INNER WEST COUNCIL

DEVELOPMENT ASSESSMENT REPORT

Application No.	DA201700205.01
Address	73 Mary Street, St Peters
Proposal	Review request under Section 96AB of the Environmental Planning and Assessment Act to review Determination No. 201700205, dated 2 August 2017, being a refusal of a Section 96 application to remove condition 2 under Determination No. 12268, dated 4 May 1989, that requires the car park to be paved and to reduce the number of car parking spaces from 136 to 119 spaces and to provide 2 motorcycle spaces, 30 bicycle spaces and 2 loading zones.
Date of Lodgement	30 August 2017
Applicant	Jvmc Pty Ltd & Chalak Holdings Pty Ltd
Owner	JVM Holdings Pty Ltd & Chalak Holdings Pty Ltd
Number of Submissions	2 (including 1 in support of the application)
Value of works	Nil.
Reason for determination at Planning Panel	A request made under Section 96AB of the <i>Environmental Planning & Assessment Act 1979</i> and there is no substantial change in recommendation on the matters subject of the Review.

ANNEXURE A: PLANS

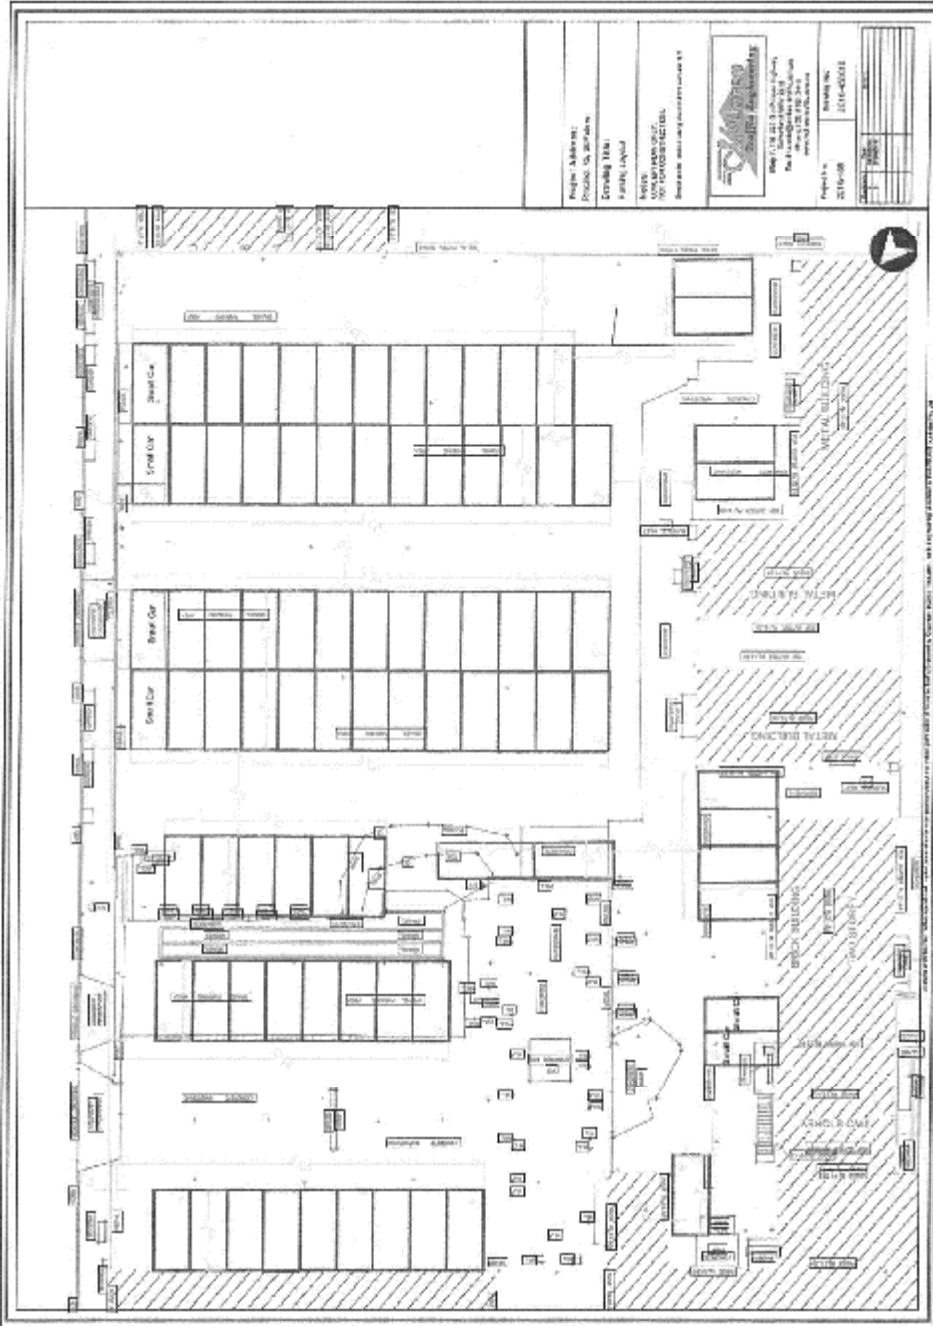
- The small internal ramp shown has a gradient of 15-16%. Whilst this exceeds the typical 12.5% (1:8) transition, the ramp length of approximately 5m allows successful vertical clearance for a B85/B99 vehicle as per AS2890.1:2004. AS2890.1:2004 permits grade changes of up to 18% as per Clause 2.5.3 of AS2890.1:2004.
- Car parking spaces marked 26, 39, 52 & 65 on the cited plans are designated as "small car" parking spaces only to accommodate the minor reduction in the blind aisle provision (total end space width of 3.2m, below the 3.5m indicated on the cited plans).

Pavement surface is not part of this certification, nor any parking locations beyond that shown in Annexure A.

I (Craig McLaren) hereby certify that the car parking layout, as shown in the listed plans and subject to the listed variations and exclusions, complies with the relevant clauses of those standards listed.
